TAS 24-1 / D214944
Pavement Rehabilitation and Miscellaneous Work
from MP 347.1 to MP 351.4 EB/WB
in Ontario County

QUESTIONS AND ANSWERS

PAVEMENT TRANSITION - TO EXISITING PCC

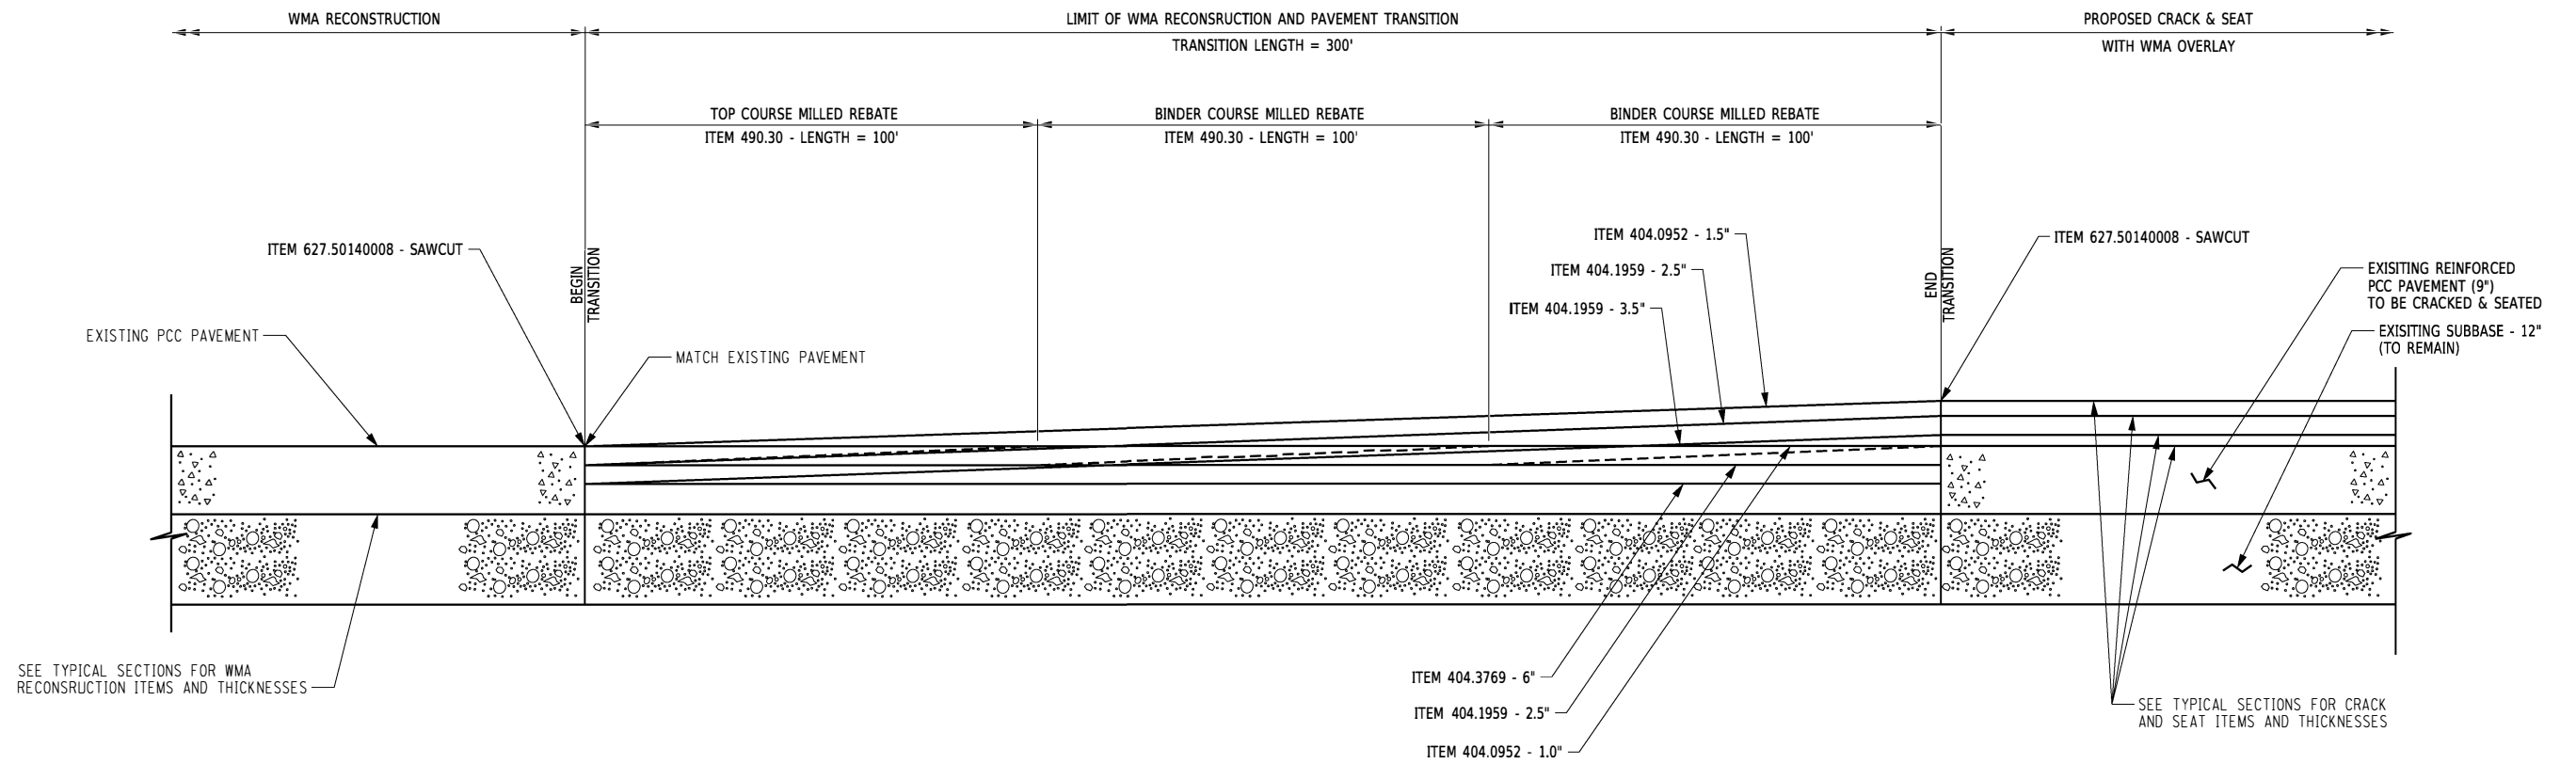
- Q32. Will the Thruway be issuing a detail for the transitions from reconstruction sections to overlay sections to facilitate the phasing sequence as described in Q&A A17? We need to know the Thruway's intent to pay for additional asphalt quantities as well as the milling that will be required to cut rebates into the transition areas to facilitate final overlay placement.

- A32. A sample detail is supplied (on Page 9) that may be acceptable for the transition from reconstruction sections to the overlay sections.
